NOTICE OF A TYPE II DECISION ON A PROPOSAL IN YOUR NEIGHBORHOOD

CASE FILE NUMBER: LU 12-200244 DZ

REVISIONS TO PREVIOUSLY APPROVED BUILDING (LU 11-160898 DZM)

OHSU / OHSU COLLABORATIVE LIFE SCIENCES BUILDING
 DESIGN REVIEW DRAWINGS OCTOBER 23, 2012

LEVEL 1 PLAN EXHIBIT C.33R

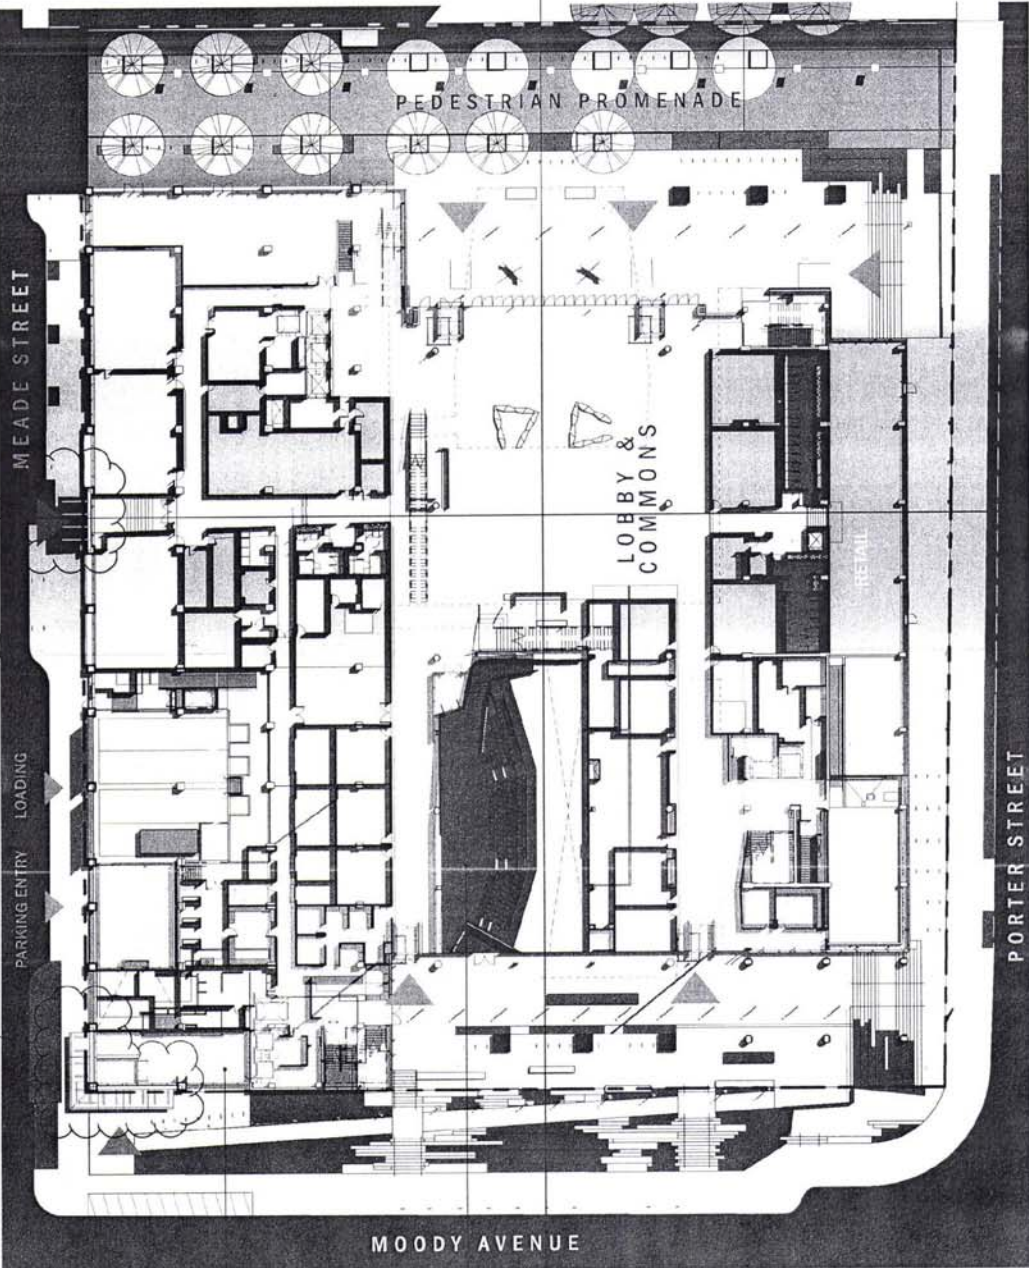
- A. Applicant's Submittal
 1. List of proposed changes
 2. Originally approved drawings
- B. Zoning Map (attached)
- C. Plans/Drawings:
 1. **C.33R** – North West canopy color changed from red glass to silver 1/8” thick aluminum metal panel. (attached)

CANOPY CHANGED TO 1/8" ALUMINUM SILVER METAL PANEL
 CANOPY CHANGED TO 1/8" ALUMINUM RED METAL PANEL
